Engineering Change Notice 2023-08.USA

Product Line:	NP*X* 1/4" plugs	ECN Date:	15-Nov-2023
		ECN-No:	2023-08.USA

Change:	Bushing redesign
---------	------------------

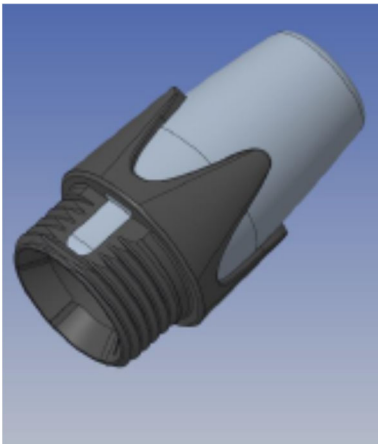
The Neutrik logo has been added to the exterior of the bushing to ensure better recognizability.

Additionally, the injection molding location has been relocated to the threaded area so that it is not visible on the assembled plug.
